MONTGOMERY COUNTY HISTORIC PRESERVATION COMMISSION
STAFF REPORT

Address:	7515 Carroll Ave., Takoma Park	Meeting Date:	6/26/2024
Resource:	Contributing Resource Takoma Park Historic District	Report Date:	6/18/2024
Applicant:	Sarah Brookshier (Michael Lucy, agent)	Public Notice:	6/12/2024
Review:	HAWP	Tax Credit:	No
Permit Number:	1073431	Staff:	Chris Berger
PROPOSAL:	Deck alteration and expansion.

Figure 4: The proposed deck plan.

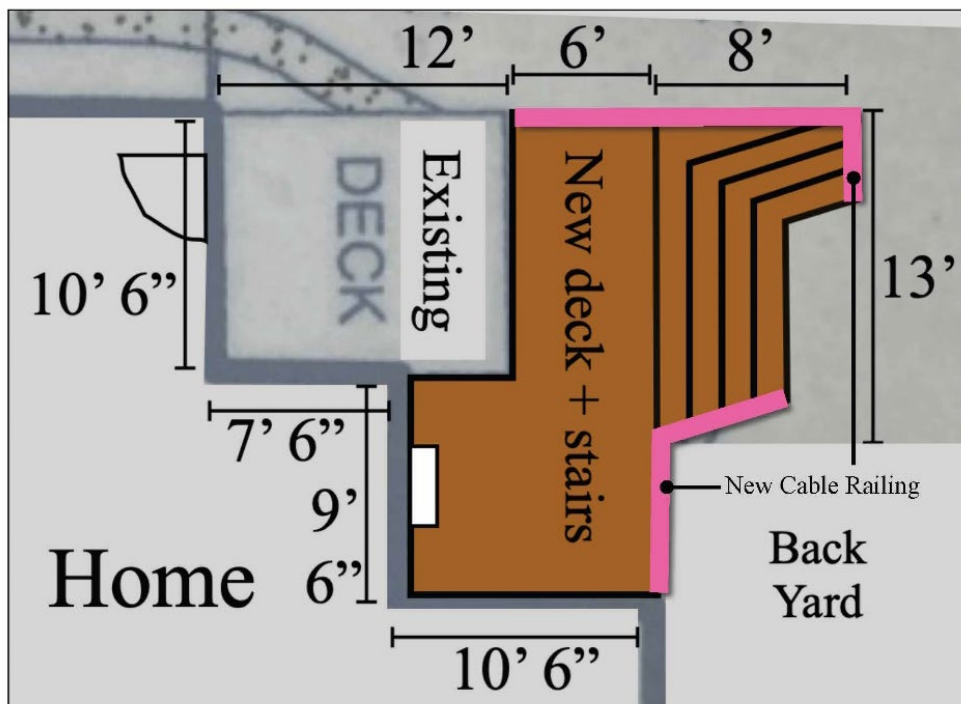
1. Applicant must revise the plans to show the existing railing will be replaced as was stated by the agent in the June 12, 2024, email included as Attachment A to the staff report.
2. Applicant must provide a specification for the composite decking and railing.

Staff seeks a condition that the applicant revise the plans to indicate the placement of the new handrails to reflect the description made by the applicant’s agent in a June 12, 2024, email.

- Will the railing on the existing deck be removed or retained? Removed and replaced
- What will be the material of the new deck railing? Wood, paintable composite and stainless steel metal cable
- What will be the material of the proposed stair treads and risers? Paintable composite or wood
- Will railings be installed to either side of the stairs? Yes, and will meet all County Code Requirements

Deck + Railing Plan
Revised 6/17/24

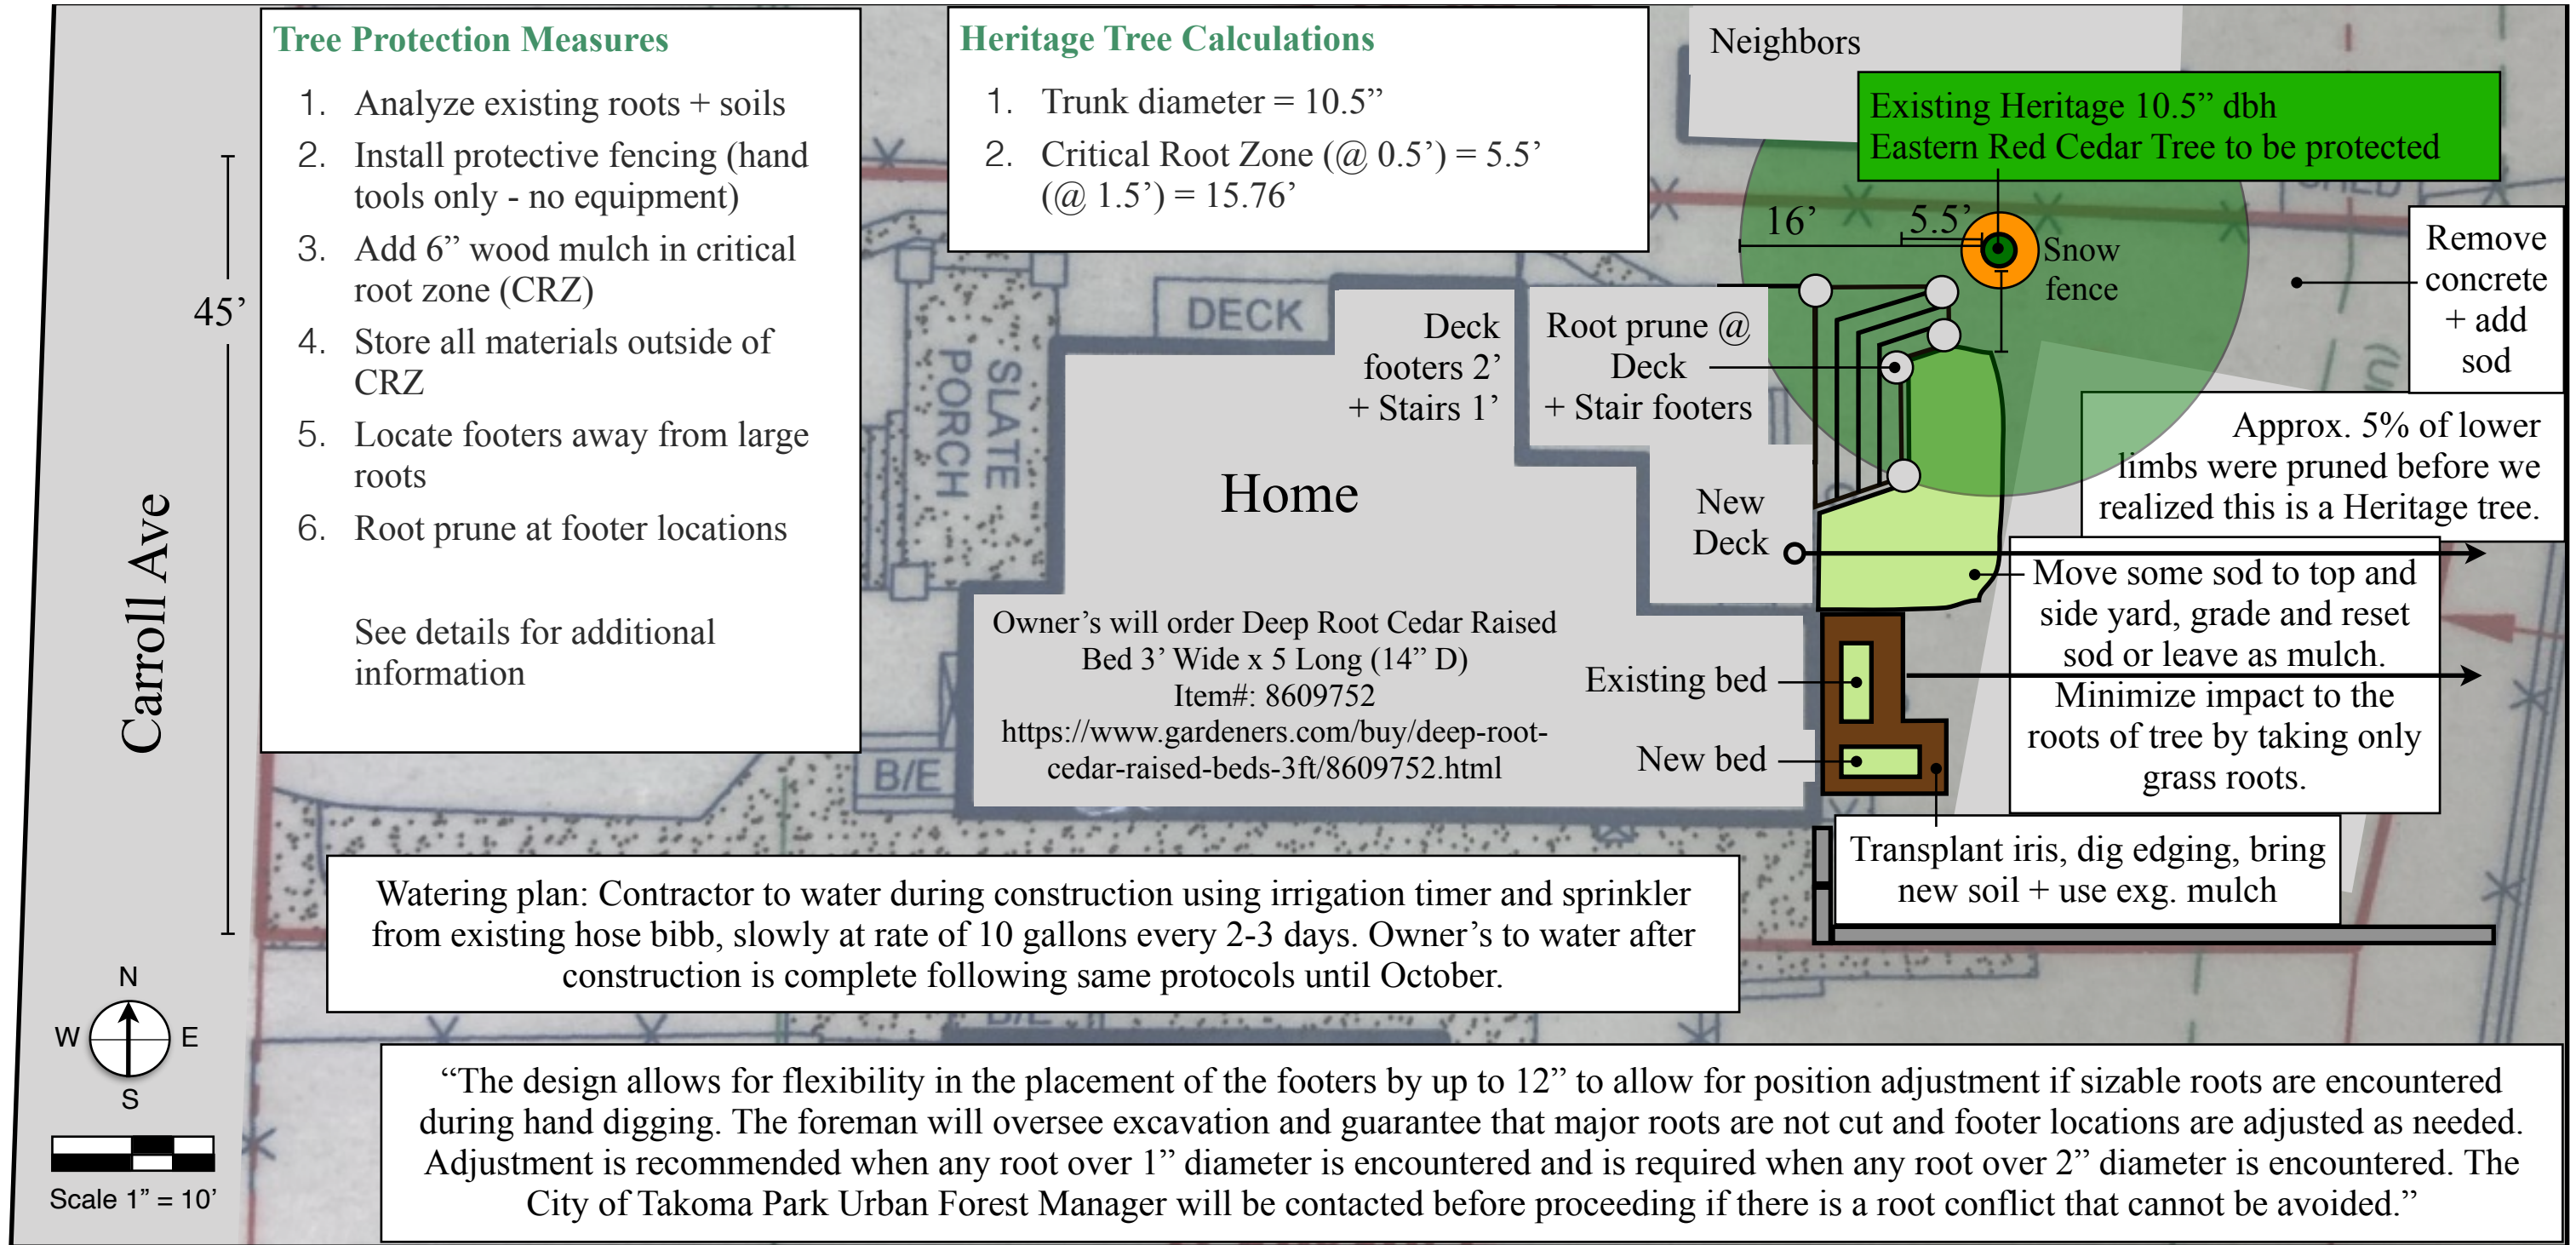
- Will the railing on the existing deck be removed or retained?
- What will be the material of the new deck railing?
- What will be the material of the proposed stair treads and risers?
- Will railings be installed to either side of the stairs?

- The Historic Preservation Commission has not approved non-paintable composite decking and railing such as Timbertech for contributing properties in the Takoma Park Historic District. If you would like to proceed with Timbertech, staff will recommend in the staff report denial of that material and installation instead of either wood decking and railings or a paintable composite such as Aeratis or Acre.
- If you change all the deck materials to wood, staff can approve administratively and the work would not require Historic Preservation Commission review.

For the decking material we would now like to use a paintable composite or wood.
